The Commission has issued the enclosed Amendments Nos. 27 and 27 to Facility Operating Licenses Nos. DPR-44 and DPR-56 for the Peach Bottom Atomic Power Station, Units Nos. 2 and 3. These amendments consist of changes to the Technical Specifications and are in response to your requests dated August 26, 1976; May 6, 1977; September 21, 1977 and October 31, 1977. Your request to revise torus temperature logging requirements is still under review and is not included in these amendments.

PEACH BOTTOM ATOMIC POWER STATION, UNIT NO. 2

AMENDMENT TO FACILITY OPERATING LICENSE

ATTACHMENT TO LICENSE AMENDMENT NO. 37

FIGURE 6.2-2

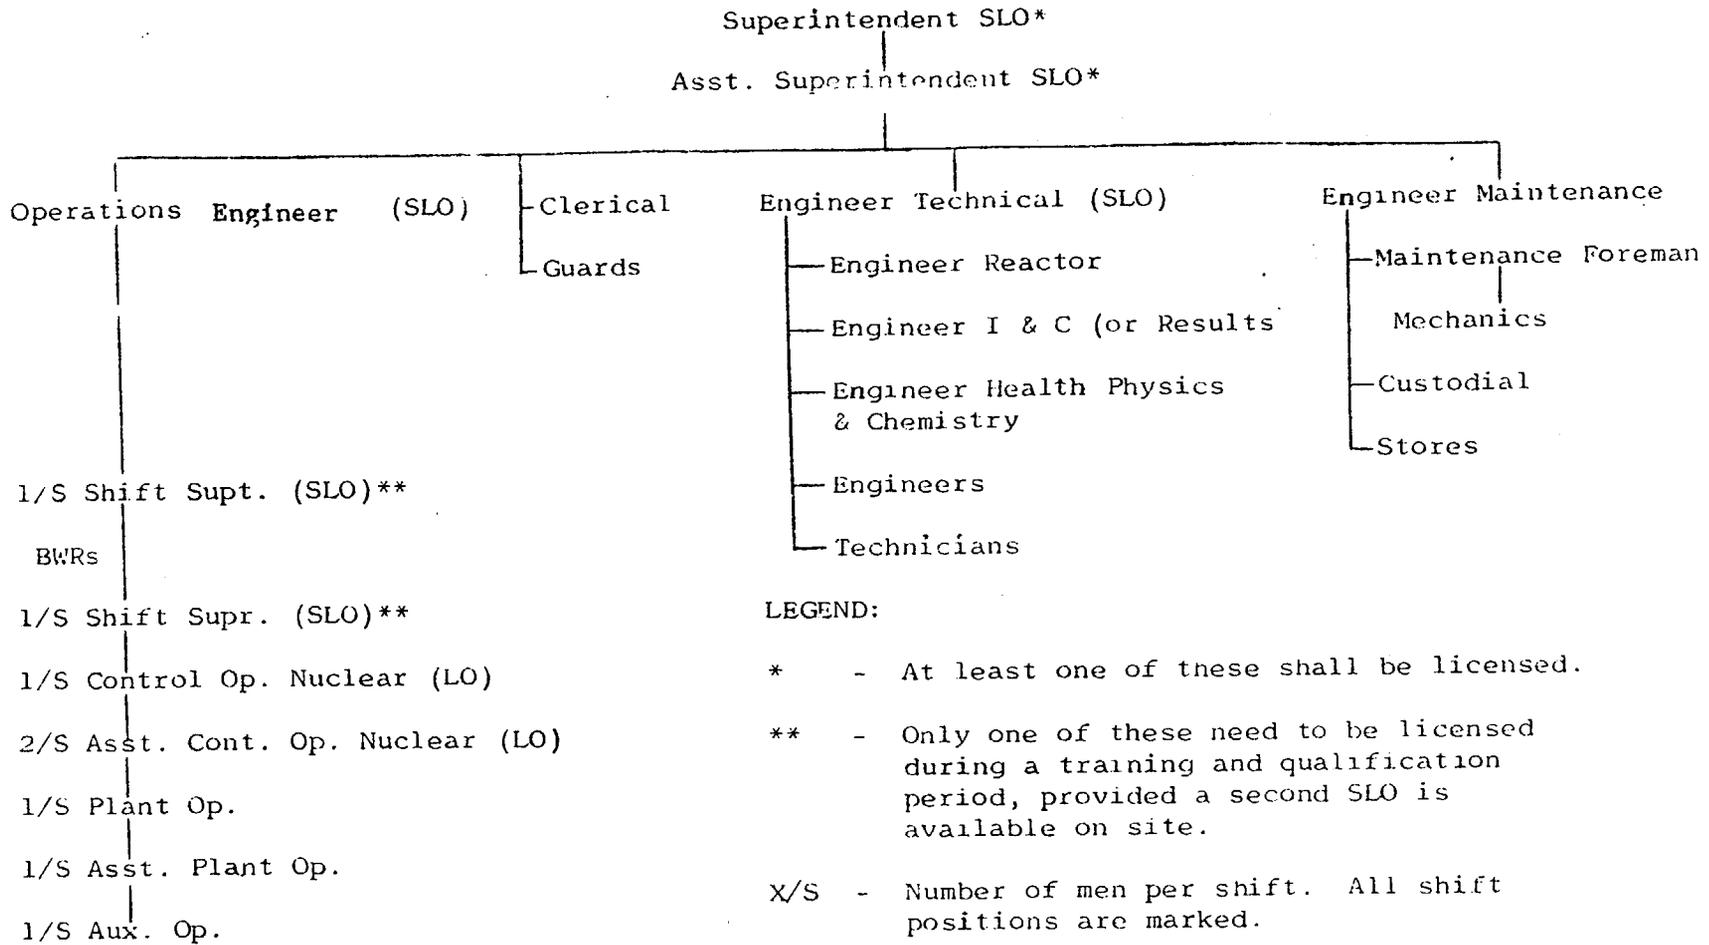
- 6.2.2 The facility organization shall be as shown on Figure 6.2-2 and:
- a. Each on duty shift shall be composed of at least the minimum shift crew composition shown in Figure 6.2-2.
 - b. At least one licensed operator shall be in the control room and assigned to each reactor that contains fuel.
 - c. At least two licensed operators, excluding the operator on the second unit, shall be present in the control room during reactor start-up, scheduled reactor shutdown and during recovery from reactor trips.
 - d. An individual qualified in radiation protection procedures shall be on site when fuel is in the reactor.
 - e. ALL CORE ALTERATIONS shall be directly supervised by either a licensed Senior Reactor Operator or Senior Reactor Operator Limited to Fuel Handling who has no other concurrent responsibilities during this operation.

The licensee proposed to revise the plant organization for conduct of plant operations and the membership of the PORC by adding an Operations Engineer, licensed as a Senior Reactor Operator. This position has the responsibility for planning and coordinating operations in accordance with the Technical Specifications. We have reviewed the licensee's proposal and determined that the total expertise of the staff will not be reduced but will be maintained at an acceptable level. Further we have determined that the function and qualification of the PORC have not been altered by the proposed revision and therefore it is acceptable.

FIGURE 6.2-2

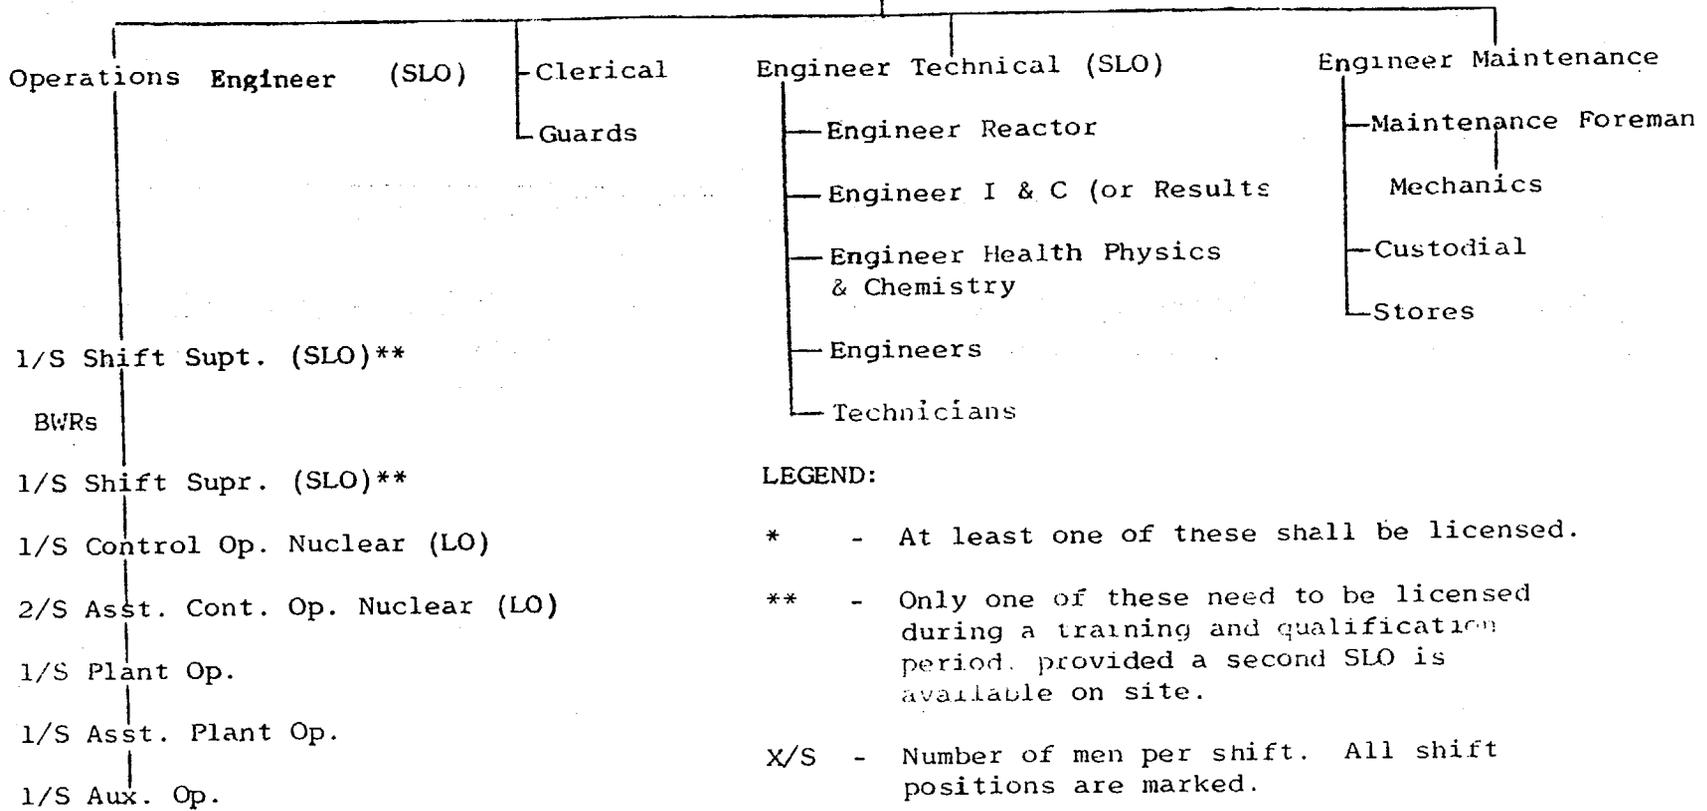
- 6.2.2 The facility organization shall be as shown on Figure 6.2-2 and:
- a. Each on duty shift shall be composed of at least the minimum shift crew composition shown in Figure 6.2-2.
 - b. At least one licensed operator shall be in the control room and assigned to each reactor that contains fuel.
 - c. At least two licensed operators, excluding the operator on the second unit, shall be present in the control room during reactor start-up, scheduled reactor shutdown and during recovery from reactor trips.
 - d. An individual qualified in radiation protection procedures shall be on site when fuel is in the reactor.
 - e. ALL CORE ALTERATIONS shall be directly supervised by either a licensed Senior Reactor Operator or Senior Reactor Operator Limited to Fuel Handling who has no other concurrent responsibilities during this operation.
